US Serial No.: 10/829,049 Docket No.: 0140-4224

<u>Amendment</u>

REMARKS

The above amendments and following remarks are responsive to the non-final Office Action mailed October 18, 2006. Upon entry of the above amendments, Claims 1, 5, 7, 12, and 22 will have been amended, Claims 2-4 and 13, 14, 16, 17 will have been canceled, without prejudice or disclaimer, and Claims 6, 8, 10, 11, 14, 15, and 18-21 will have been withdrawn as being drawn to a non-elected species. Of the withdrawn claims, Claims 6, 8, and 15 will have been amended to be consistent with the amendments to base Claim 1 to facilitate rejoinder by Examiner upon allowance of Claim 1. Claims 1, 5-12, 15, and 18-22 will be pending. No new matter has been introduced. Entry and reconsideration are respectfully requested.

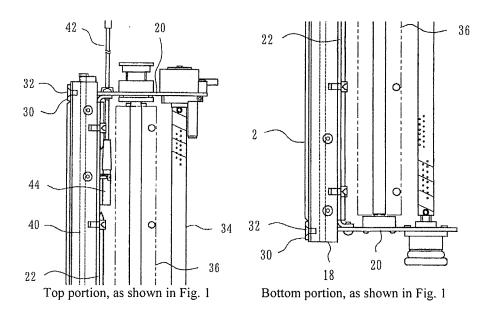
The Examiner has also indicated that

"it is unclear whether the recitation of 'plates 30" on p. 6, line 14 is correct in view of what Figs. 1 and 3 show for numeral **30**. It would appear that "plates 30" should then read –pates 20-- but clarification is respectfully requested. Accordingly, reference **30** in Figs. 1 and 3 would then need to be properly referenced in the specification."

Figure 1 depicts both (1) the side plates 20 of the frame of the cleaning unit and (2) the plates 30 that are engaged with the opposite ends 12 of the base portion 8. Side plates 20 are disclosed, at least on Page 6, Lines 4-6, and depicted in at least Figure 1, as being connected by the back-up bar 22 on which the support bar 18 is mounted. Plates 30, on the other hand, are disclosed, at least on page 6, Lines 13-16, and depicted in at least Figure 1, as being engaged with the opposite ends 12 of the base portion 8, wherein the plates 30, base portion 8, and the

support bar 18 are fixed to each other by means of screws 32. The Examiner's attention is directed to the portions of Figure 1 included below in which side plates 20 are connected to the support bar 18 via back-up bar 22, and plates 30 are connected to the support bar 18 on a side opposite to side plate 20.

Since side plates 20 and plates 30 are disclosed and depicted as separate elements, Applicant respectfully submit that no amendments to either the specification and/or drawings is necessary.
